Eastern Harbour City

Submissions Report

Sydney Eastern City Planning Panel No.	2017SCL040 RPA
LGA	Canada Bay LGA
Proposal	<p>The planning proposal seeks to:</p> <ul style="list-style-type: none">• rezone land from IN1 General Industrial to R3 Medium Density Residential;• increase the maximum permissible floor space ratio (FSR) from 1:1 to 1.6:1; and• increase the maximum height of the building (HOB) from 12 metres to 25 metres. <p>The proposal will also identify the land as a 'Flood Planning Area' as per clause 6.8 of Canada Bay LEP 2013, and as an 'Intensive Urban Development Area' as per clauses 6.9 and 6.10 of Canada Bay LEP 2013.</p>
Address	7 Concord Avenue, Concord West Lot 1 DP 219742
Applicant/Owner	Elton Consulting
Submissions	<ul style="list-style-type: none">• Public submissions (17)• Public agency submissions (7)• Submissions from Canada Bay Council (2)• Submission from the Hon. Jodi McKay MP, State Member for Strathfield• Proponent response to submissions (2)

Figure 7: Revised Master Plan Concept

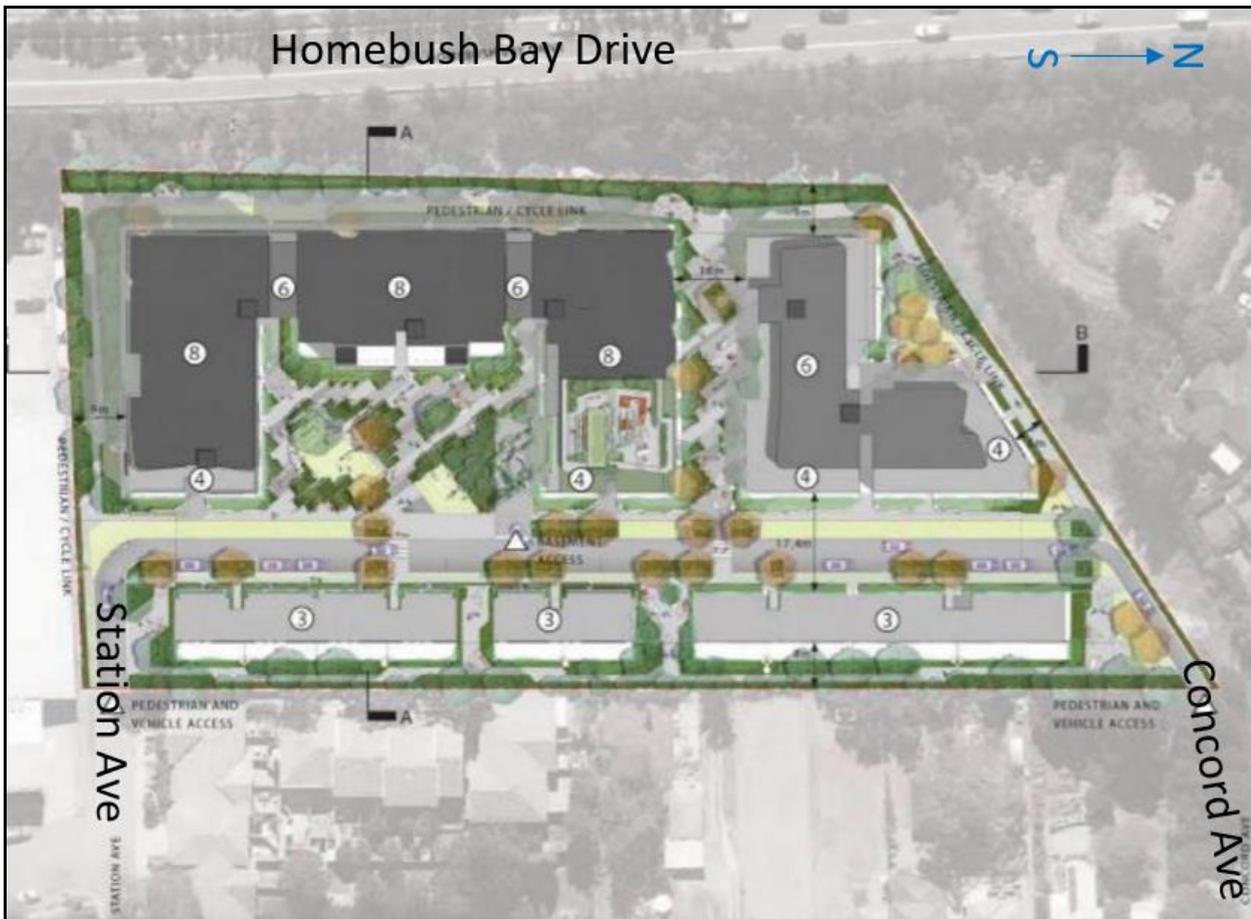
The revised planning proposal includes a revised Master Plan Concept (**Figure 7**) with the following key features:

- 261 new dwellings with building heights ranging from 3 to 8 storeys;
- a new north/south street through the site and cycle/pedestrian linkages;
- the transition of building heights from three storeys to eight storeys along Homebush Bay Drive; and
- a flood mitigation solution that preserves the current flood storage on the site and raises the height of common areas, private courtyards and internal roads substantially above the 100-year Average Recurrence Interval (ARI).

Figure 8: Mitigation option supporting the exhibited plan (Elton, planning proposal 2018 -Source: Antoniades Architects and Catchment Simulation Solutions 2018)

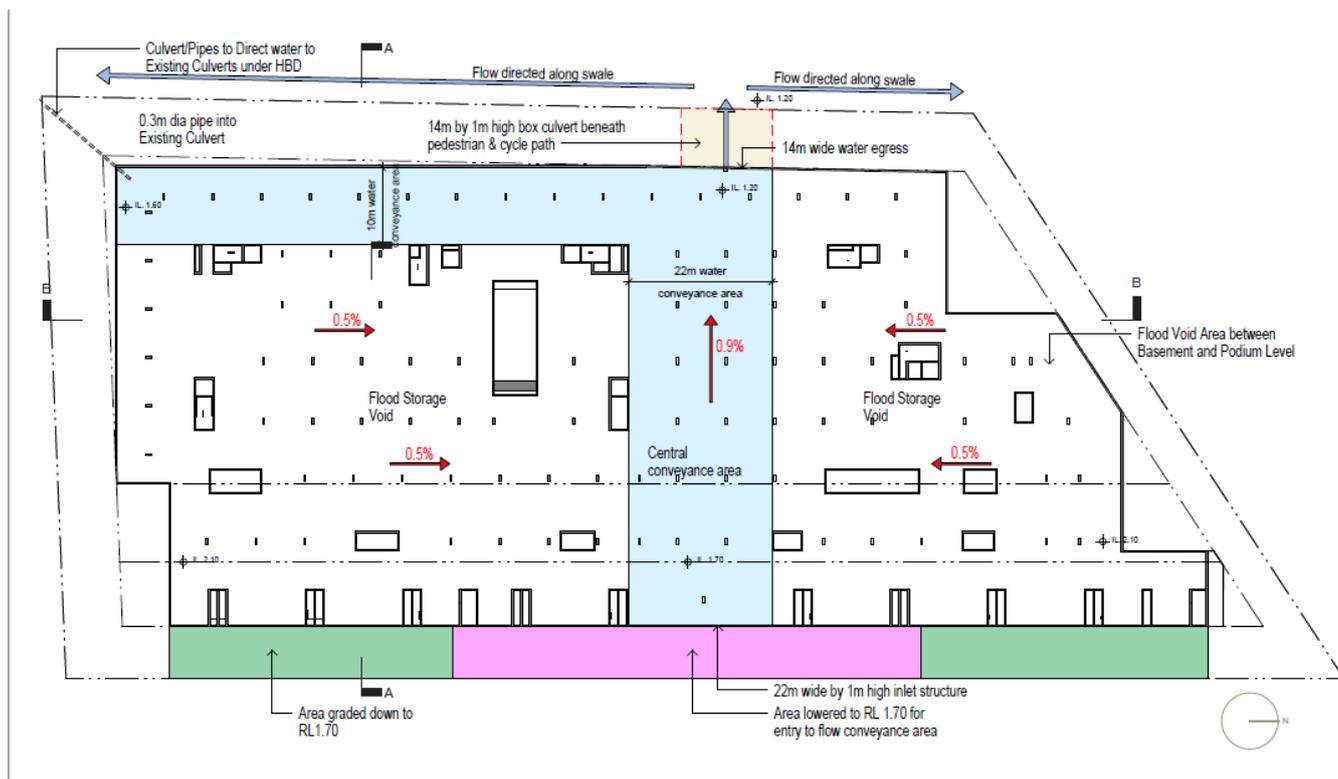
In summary, the mitigation option (**Figure 8**) depicts a highly engineered intervention including:

- a 14-metre wide central conveyance area extending beneath the elevated ground floor of the development;
- a 22-metre wide inlet structure to allow water near the eastern site boundary to enter the conveyance area;
- the inclusion of a 14-metre wide opening along the western site boundary towards Homebush Bay Drive;
- an additional 10-metre wide conveyance area running from the central conveyance area to the south-western corner of the site;
- the inclusion of a low flow pipe to discharge across Homebush Bay Drive; and
- additional flood storage areas to the north and south.

The flood assessment by Hydro Spatial (2018) estimates that the site is affected by depths of approximately 0.8 m in the 1% Annual Exceedance Probability (AEP) event and 2.4 m in the PMF event. In summary the assessment considers that in any given year the 1% AEP event has a 1% chance of occurring, or a 55.25% chance of occurring over an 80-year time frame. It is a reasonable expectation that a flood of this magnitude will occur over a lifetime. However, it is very unlikely that a flood with the magnitude of a PMF will occur over a lifetime. The proposal is discussed in more detail later in the report under key issues – 4.1 Flooding.
